- 1. APOLOGIES FOR ABSENCE**
- 2. DECLARATIONS OF INTEREST (IF ANY)**
- 3. CONSIDER NOTICE OF REVIEW REQUEST: 63 JOHN STREET, HELENSBURGH, G84 9JZ (REF: 19/0006/LRB)**
  - (a) Notice of Review and Supporting Documentation (Pages 3 - 44)
  - (b) Comments from Interested Parties (Pages 45 - 64)
  - (c) Comments from Applicant (Pages 65 - 74)

**REFUSAL OF PLANNING APPLICATION 18/02163/PP  
FOR INSTALLATION OF REPLACEMENT WINDOWS  
FROM TIMBER SASH AND CASE TO WHITE UPVC  
DOUBLE GLAZED SASH AND CASE WINDOWS TO  
INCLUDE FORMATION OF REAR PATIO DOOR,  
REPLACEMENT DOOR TO SIDE ELEVATION AND  
NEW WINDOW OPENING IN GABLE WALL AT 63  
JOHN STREET, HELENSBURGH**

Reference No: 18/02163/PP  
Planning Hierarchy: Local Application  
Applicant: Nicholas and Gillian Dunn  
Proposal: Installation of replacement windows from timber sash and case to white uPVC double glazed sash and case windows to include formation of rear patio door, replacement door to side elevation and new window opening in gable wall (kitchen area).  
Site Address: 63 John Street, Helensburgh, Argyll and Bute, G84 9JZ

WINDOW ELEVATIONS  
(PROPOSED)

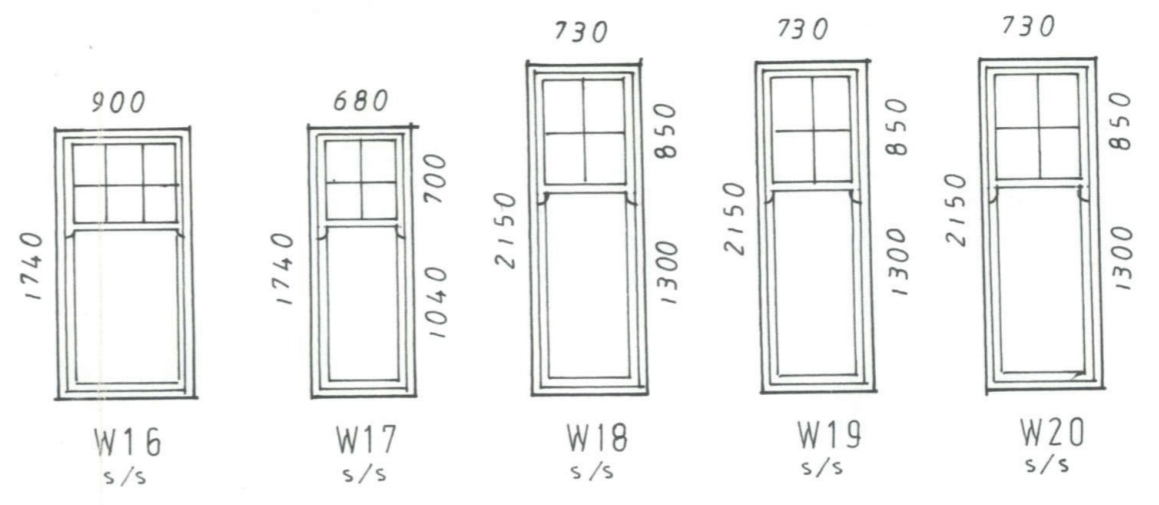
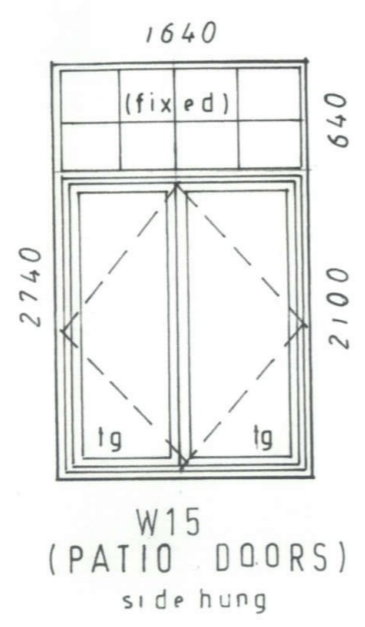
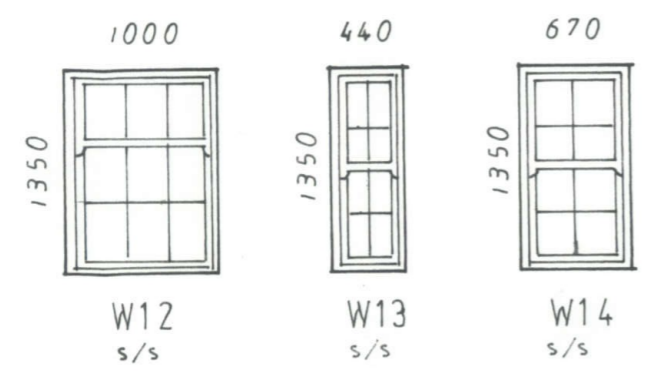
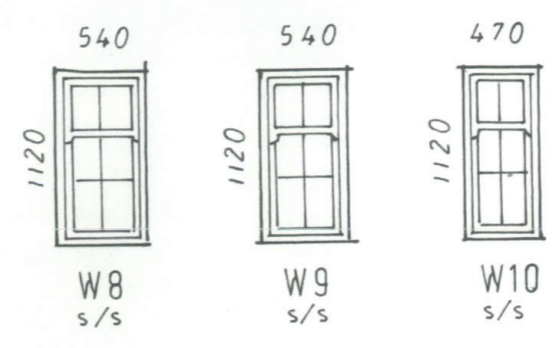
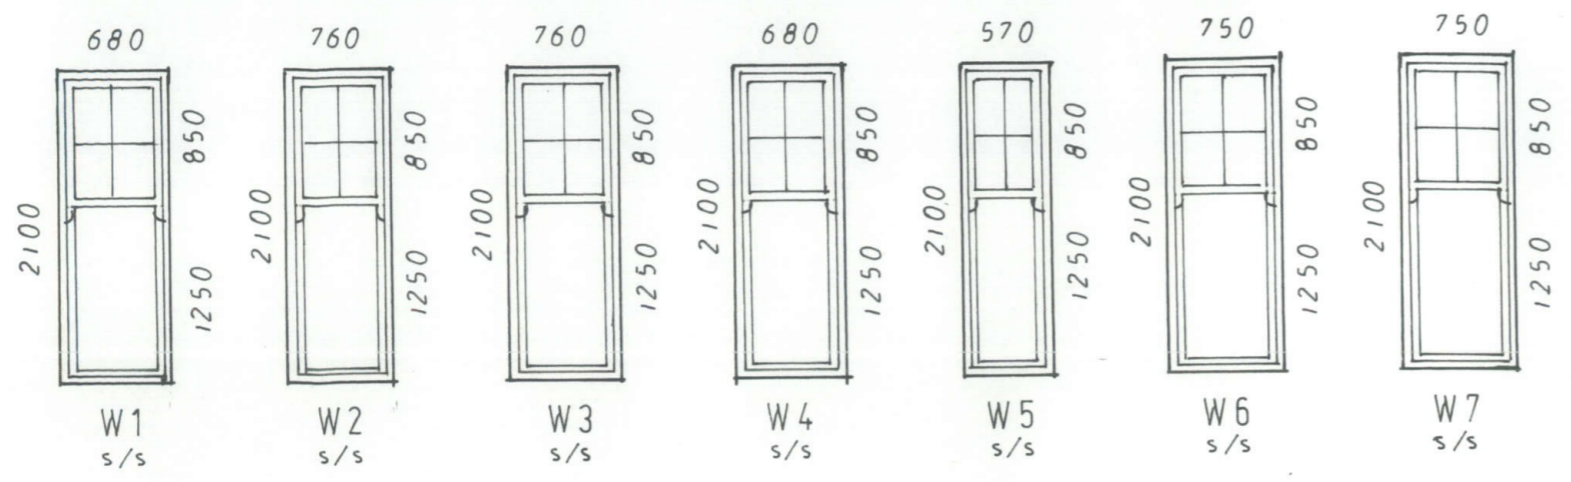
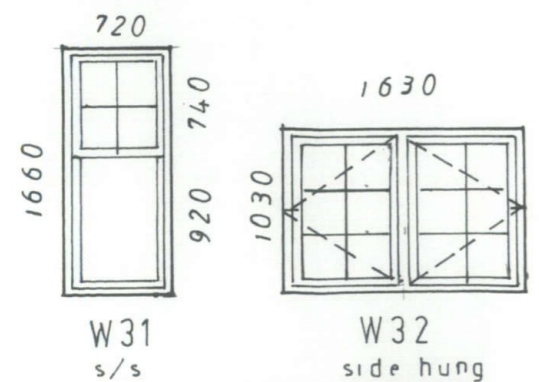
installation of 30 replacement windows which do not exactly match the original timber windows in terms of materials and appearance will be visually intrusive, visually discordant and as such detract from and undermine the character and appearance of this traditional building. This will have a detrimental effect on the integrity and architectural quality of the building as a whole and in turn will undermine the character and appearance of the conservation area. The works are therefore considered contrary to policies LDP 3(C) of the Local Development Plan (adopted 26th March 2015), SG LDP ENV16 (a) and ENV17 of the Supplementary Guidance and the council's Technical Working Note on Replacement Windows in Argyll & Bute.

Detail Plan  
 Thru Rehau Heritage Sash  
 scale 1.2

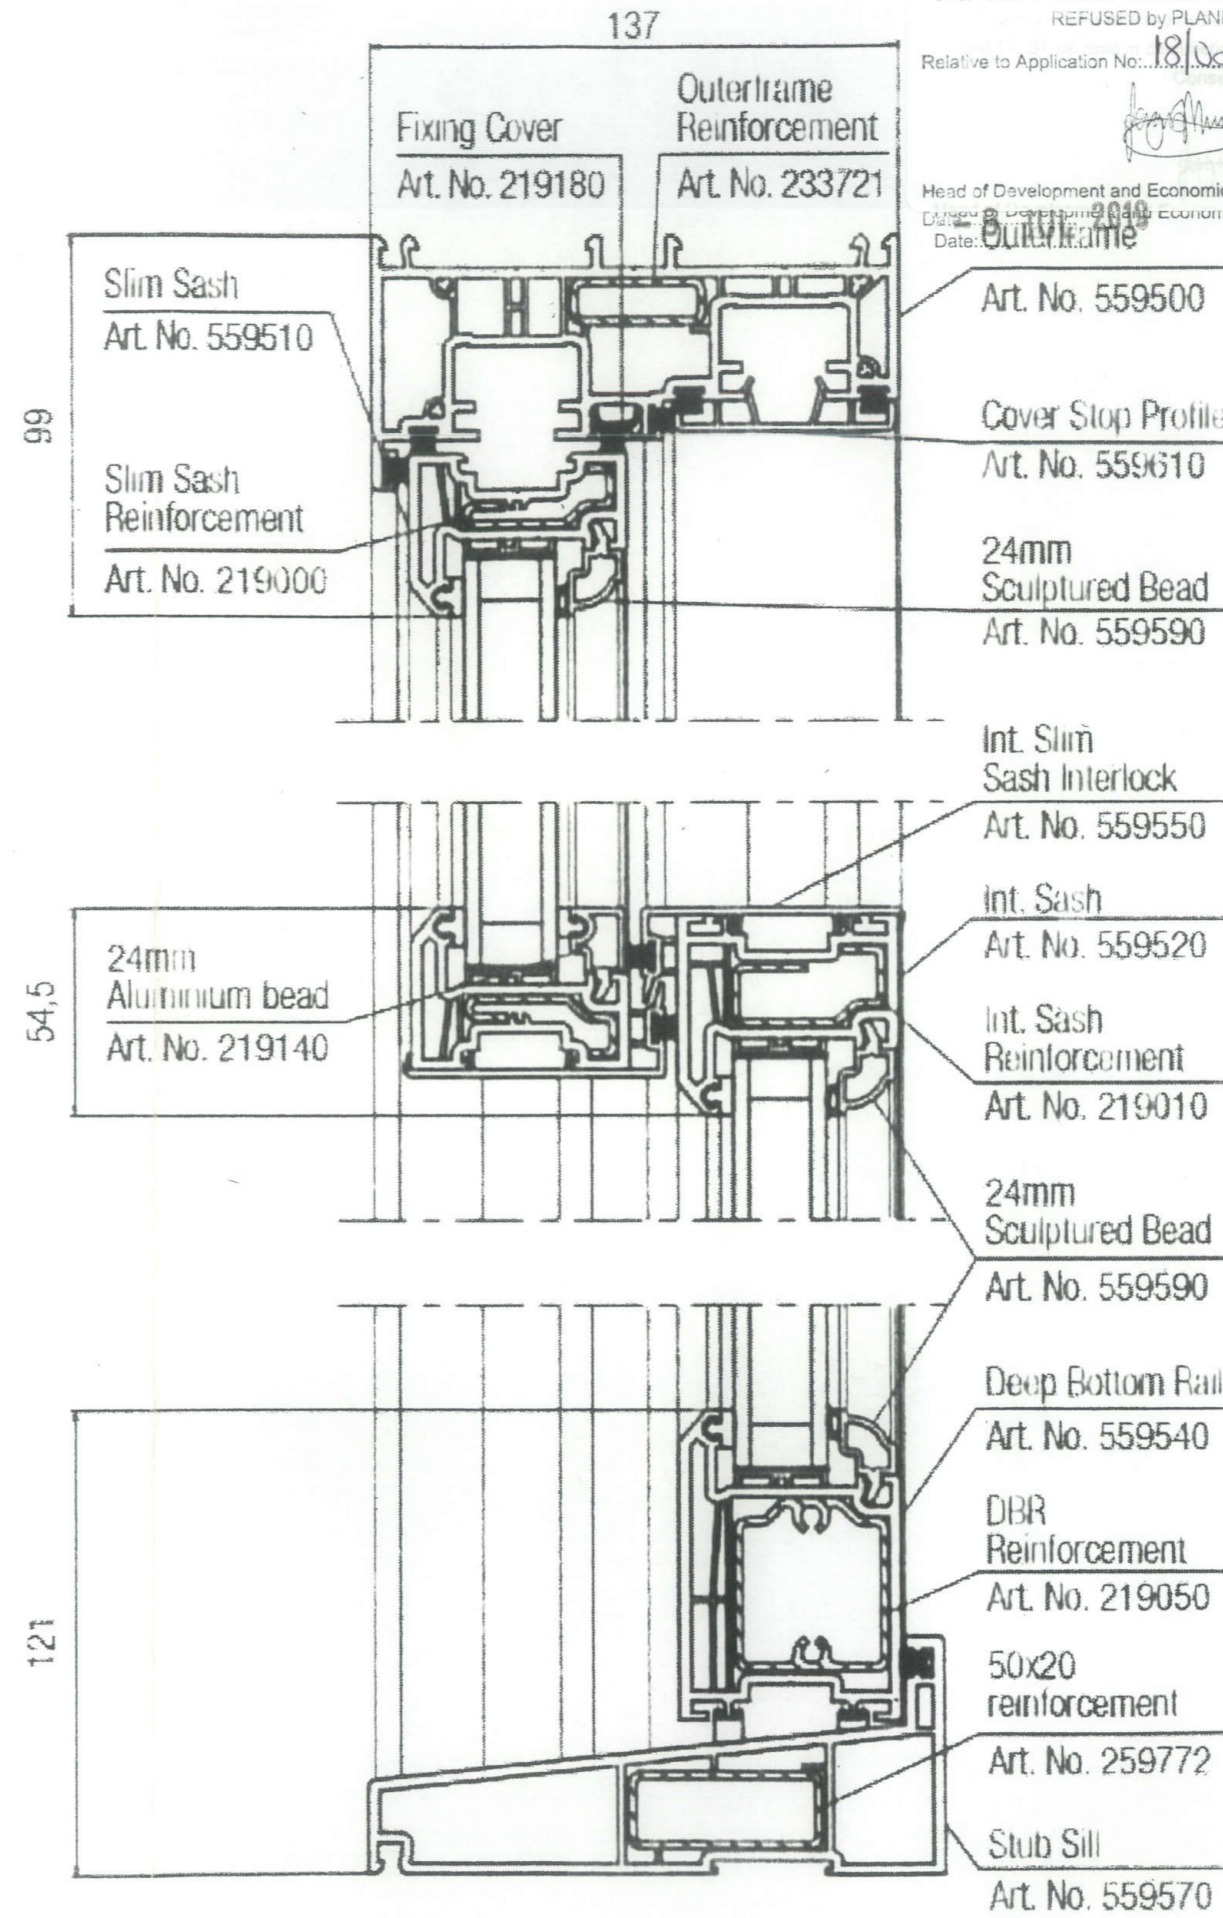
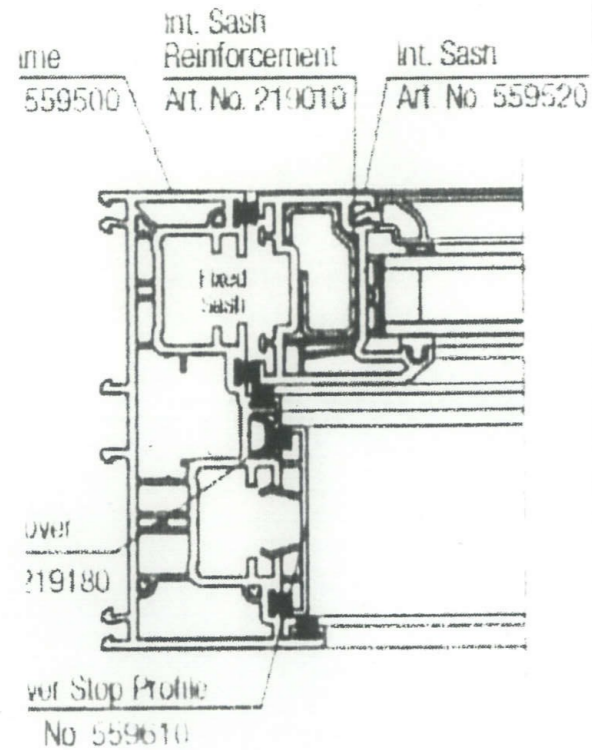
1. The windows proposed replacement windows will have non-traditional frames and surface mounted astragals, which by virtue of their inappropriate uPVC material will have an unacceptable impact upon the appearance and the architectural and historic interest of the conservation area. They would fail to preserve the character of the conservation area and are contrary to the policy position expressed in Scottish Planning Policy and Managing Change in the Historic Environment.

Planning permission is sought for the installation of 30 replacement windows, the formation of a new window opening and the formation of patio doors to 63 John Street, Helensburgh. This is a traditional, unlisted villa within the Upper Helensburgh Conservation Area. Although unlisted, this is a very attractive building with all of its original timber windows. The proposal is to replace all of these windows with sliding sash and case uPVC units. These windows will be similar in appearance to the existing windows, however the astragals will be surface mounted rather than separating the physical panes as the original windows do.

*Comment: The Council are very aware of the continuing development of window technology. In fact, replacement window applications account for a large number of householder and listed building applications. We also are aware of examples where timber windows have been replaced with uPVC sliding sash and case units. It is the Council's opinion that these windows will be visually intrusive, visually discordant and as such detract from and undermine the character and appearance of this traditional building. This will have a detrimental effect on the integrity and architectural quality of the building as a whole and in turn will undermine the character and appearance of the conservation area.*
